Legend
 Blue = Existing
 Red = Proposed
 Yellow = Questions/alternative proposed

SIGNAL PLAN: WB CAMPUS DRIVE AT BABCOCK DRIVE RECONSTRUCTION
 CITY OF MADISON, DANE COUNTY, WI
 US RAPID TRANSIT
 CITY OF MADISON
 CONTRACT NO: xxxxxxxx
 Ocr-1

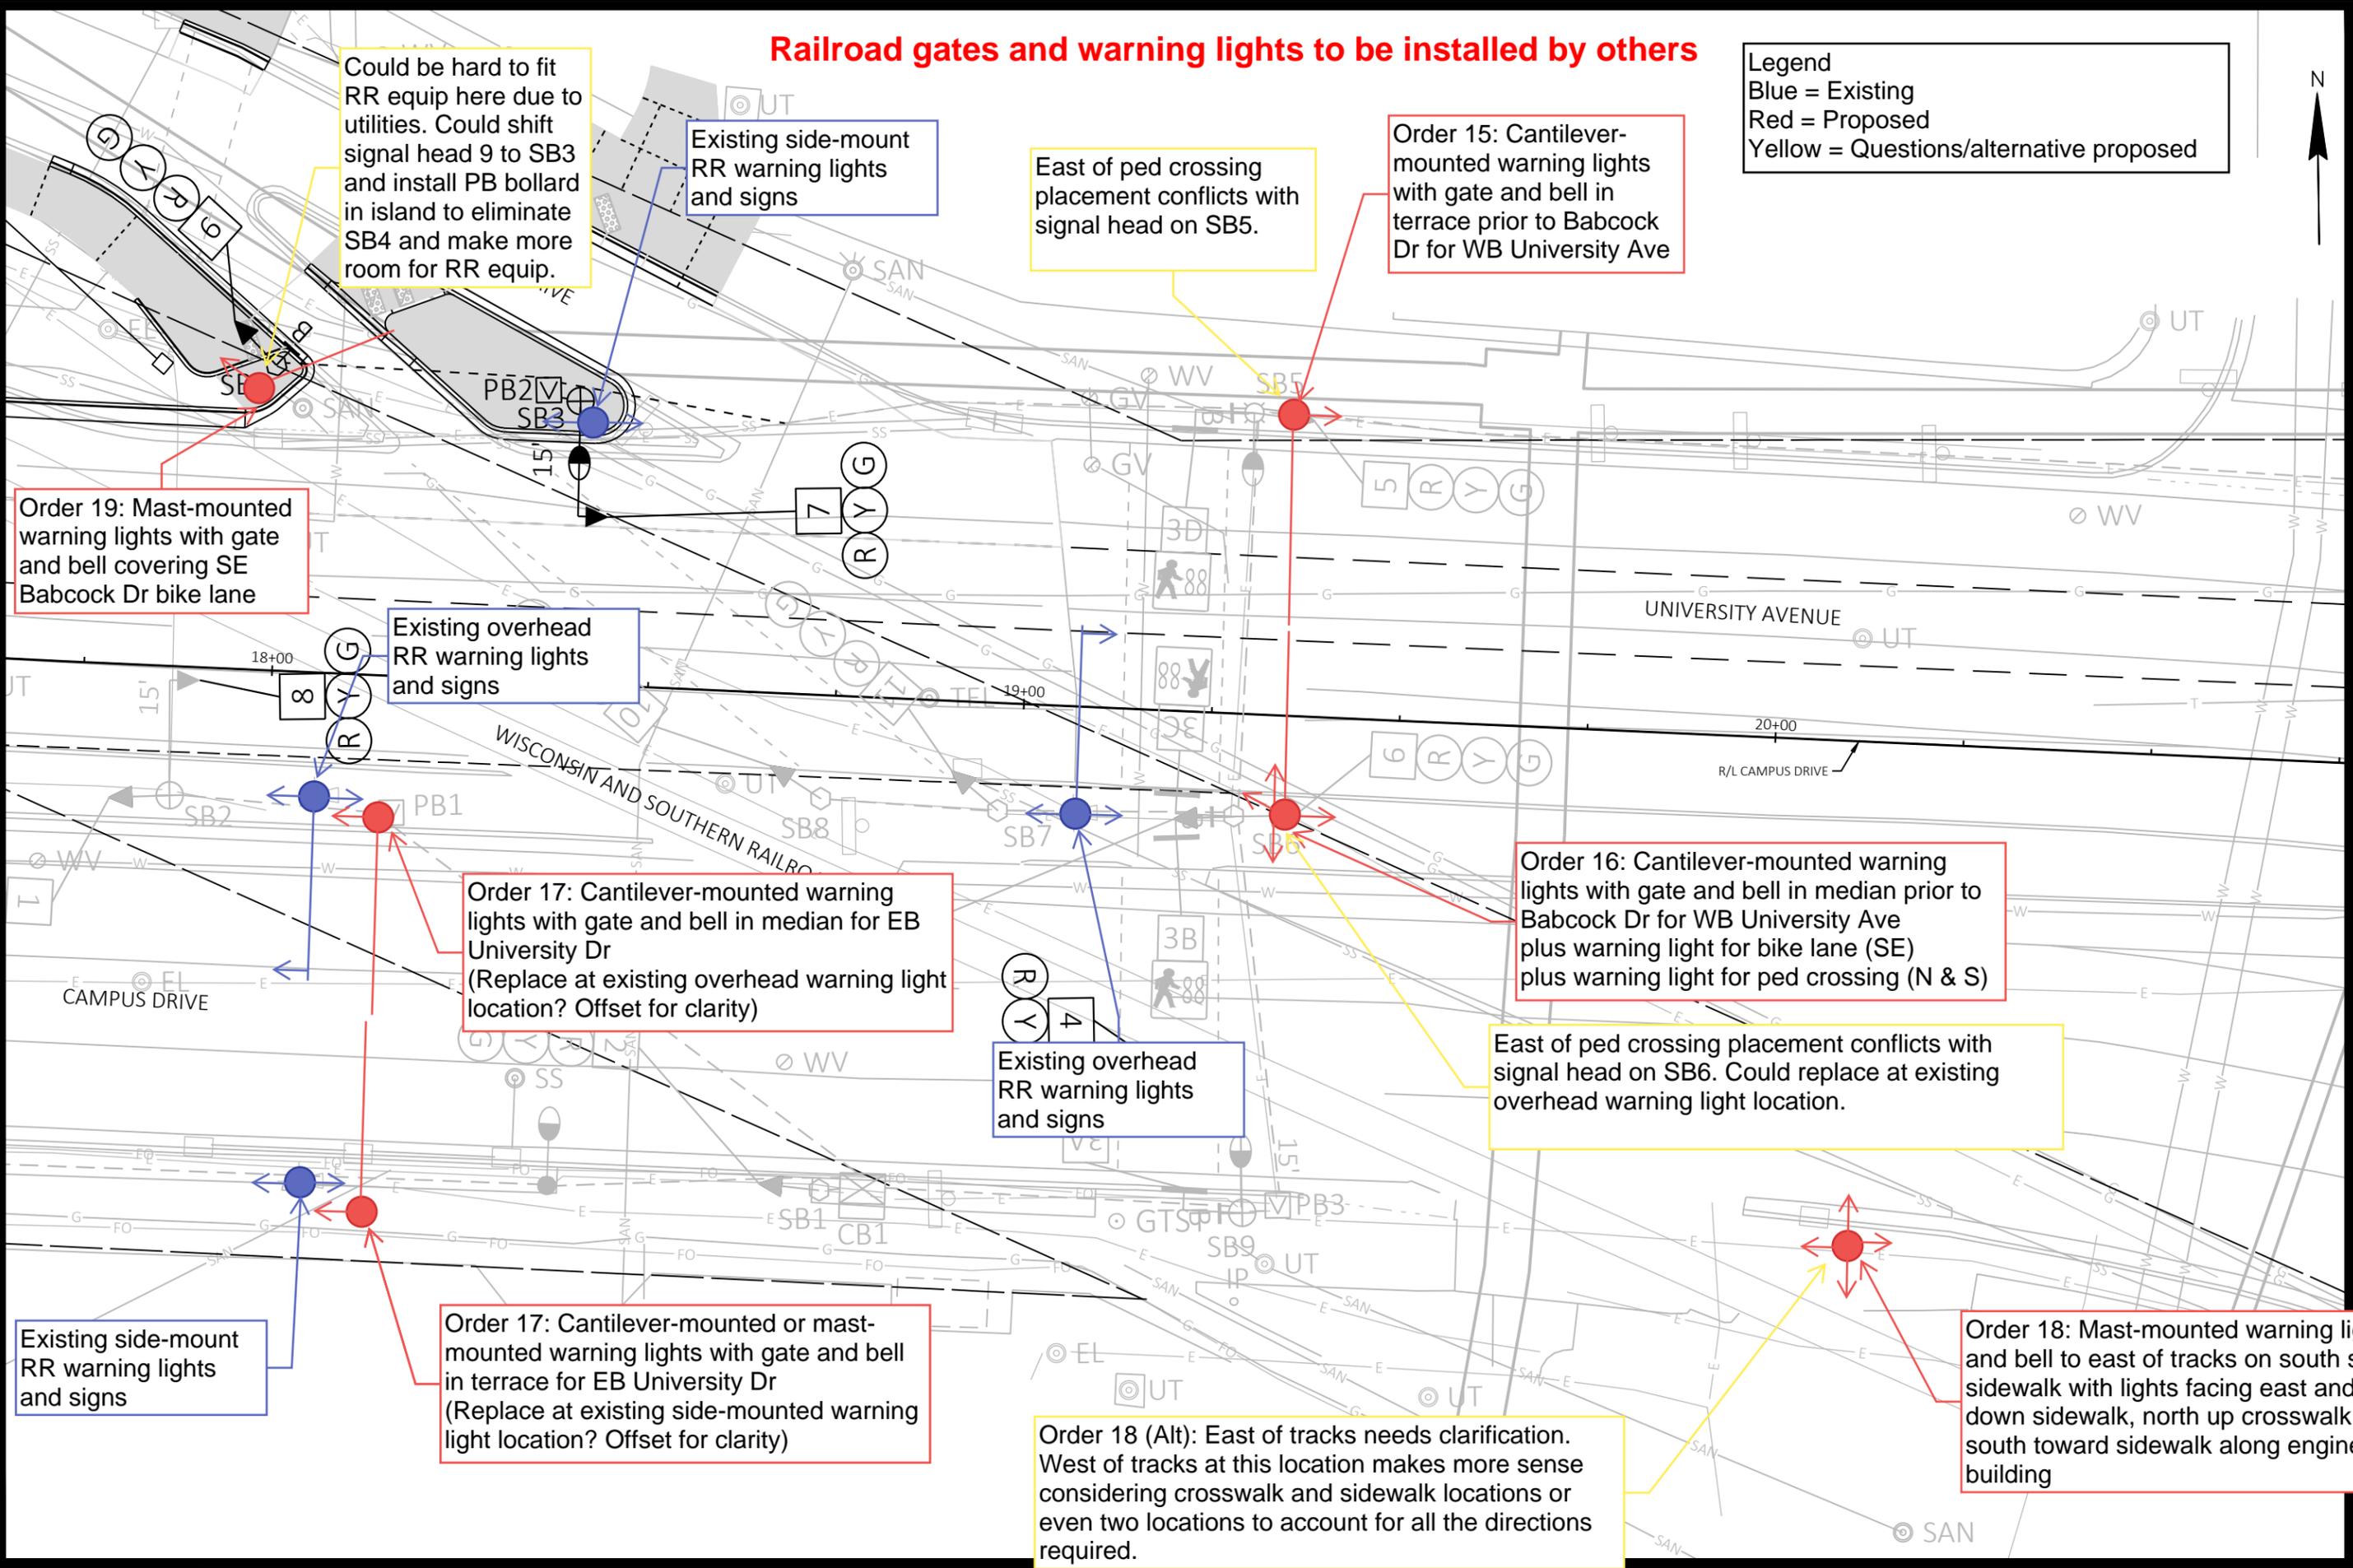
Could be hard to fit RR equip here due to utilities. Could shift signal head 9 to SB3 and install PB bollard in island to eliminate SB4 and make more room for RR equip.

East of ped crossing placement conflicts with signal head on SB5.

Order 17: Cantilever-mounted warning lights with gate and bell in median for EB University Dr (Replace at existing overhead warning light location? Offset for clarity)

East of ped crossing placement conflicts with signal head on SB6. Could replace at existing overhead warning light location.

Order 17: Cantilever-mounted or mast-mounted warning lights with gate and bell in terrace for EB University Dr (Replace at existing side-mounted warning light location? Offset for clarity)

Order 18 (Alt): East of tracks needs clarification. West of tracks at this location makes more sense considering crosswalk and sidewalk locations or even two locations to account for all the directions required.
